Informal document GRSP-58-07-Rev.1  
(58th GRSP, 7-11 December 2015,  
agenda item 19)

## **Proposal for the 01 series of amendments to Phase 1 of Regulation No. 129 (Enhanced Child Restraint Systems)**

### **Submitted by the expert from France**

### Arrangements of the approval mark

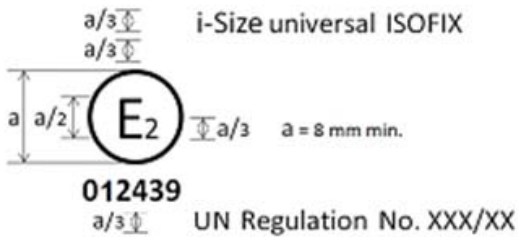
The **Enhanced** Child Restraint System bearing the above approval mark is a device capable of being fitted in any i-size compatible vehicle **seating position** and of being used for the 40 cm  $\varnothing$  - 70 cm size range and mass limit of 24 kg; it is approved in France (E 2) under the number 012439. The approval number indicates that the approval was granted in accordance with the requirements of the Regulation concerning the approval of **Enhanced Child Restraint Systems** used onboard of motor vehicles as amended by the 01 series of amendments. In addition the name of the regulation has to be identified on the approval mark followed by the series of amendment according to which the approval has been granted.

The **Enhanced** Child Restraint System bearing the above approval mark is a device not capable of being fitted in every vehicle and capable of being used for the 40 cm  $\varnothing$  - 70 cm size range and mass limit of 24 kg; it is approved in France (E 2) under the number 012450. The approval number indicates that the approval was granted in accordance with the requirements of the Regulation concerning the approval of Specific vehicle ISOFIX **Enhanced** Child Restraint Systems used onboard of motor vehicles as amended by the 01 series of amendments. In addition the name of the regulation has to be identified on the approval mark followed by the series of amendment according to which the approval has been granted.

### Arrangements of the approval mark in combination with a module mark

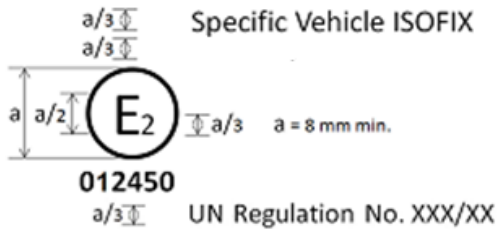
The Enhanced Child Restraint System bearing the above approval mark is a device, including module(s), capable of being fitted in any i-size compatible vehicle seating position. It is approved in France (E 2) under the number 012439. The approval number indicates that the approval was granted in accordance with the requirements of the Regulation concerning the approval of Enhanced Child Restraint Systems used onboard of motor vehicles as amended by the 01 series of amendments. In addition the name of the regulation has to be identified on the approval mark followed by the series of amendment according to which the approval has been granted.

The Enhanced Child Restraint System bearing the above approval mark is a device, including module(s), not capable of being fitted in every vehicle. It is approved in France (E 2) under the number 012450. The approval number indicates that the approval was granted in accordance with the requirements of the Regulation concerning the approval of Specific vehicle ISOFIX Enhanced Child Restraint Systems used onboard of motor vehicles as amended by the 01 series of amendments. In addition the name of the regulation has to be identified on the approval mark followed by the series of amendment according to which the approval has been granted.

### Example of arrangements of the module mark in combination with an approval mark

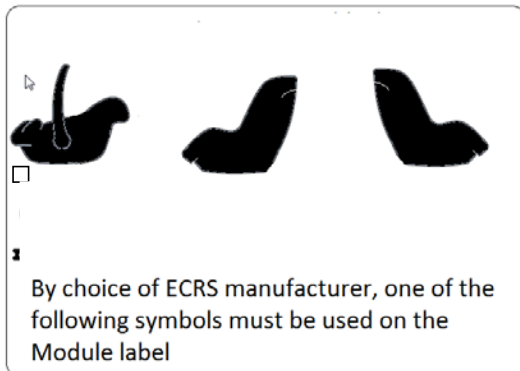
The Enhanced Child Restraint System module bearing the above module mark capable of being used for the 40 cm to - 70 cm size range and mass limit of 24 kg; it is approved under the number 012439 to be used in combination with device approved according to Regulation No. 129 under the same number 012439. The approval number indicates that the approval was granted in accordance with the requirements of the Regulation concerning the approval of Enhanced Child Restraint Systems used onboard of motor vehicles as amended by the 01 series of amendments.”

Figure 2  
Dimensions of the aluminium bottom-plate and dimensions of the aluminium backrest plate

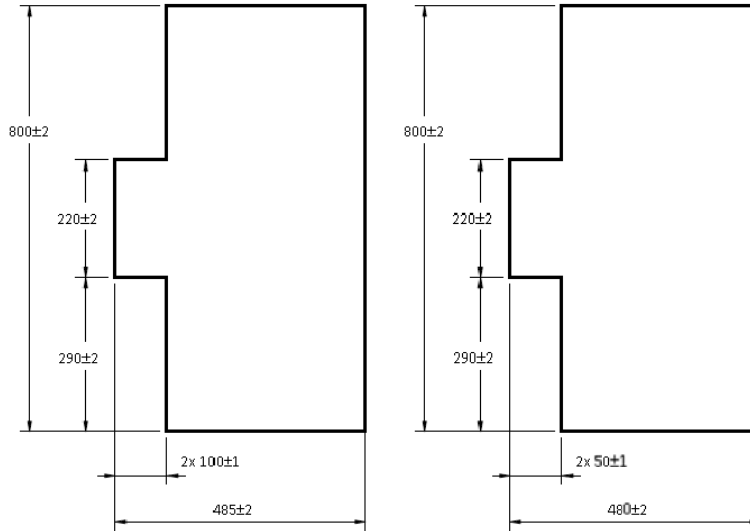
"3.1.2. Rigid seating, **made from a rigid metal sheet**, dimensions of which are given in Appendix 1 to this annex. ~~The rear part of the seating is made from a rigid sheet metal. The front part of the seating is also made of a 20 mm diameter tube;~~"

Figure 4

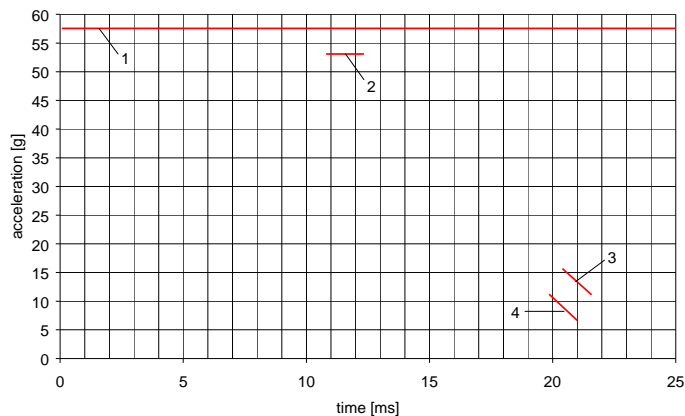
The impact surface of the door panel shall be entirely covered with a padding material of 55 mm in thickness (see Figure 1 above). The material shall comply with the performance criteria specified in paragraph 2.3. (figure 4 below) of this appendix when tested in accordance with paragraph 2.2. of this appendix.

Figure 2  
Side and Front View of the measuring device

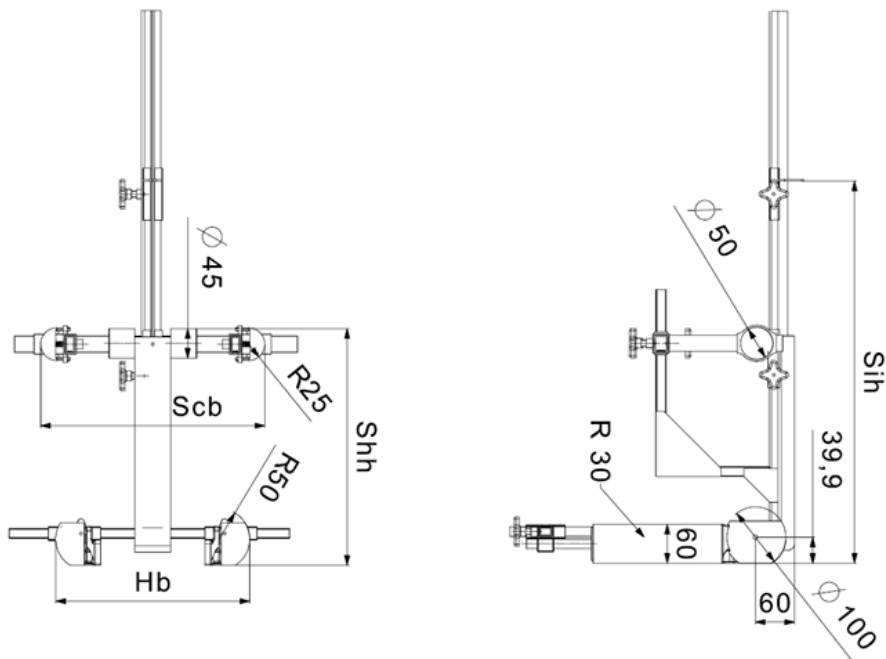
~~When~~ **All lateral dimensions are measured under a contact force of 50 N with the device described in Figure 2 of this annex and the following tolerances will be applied to the dimensions:**

**The mass of the device described in Figure 2 of this annex shall be 10 kg +/- 1 kg"**
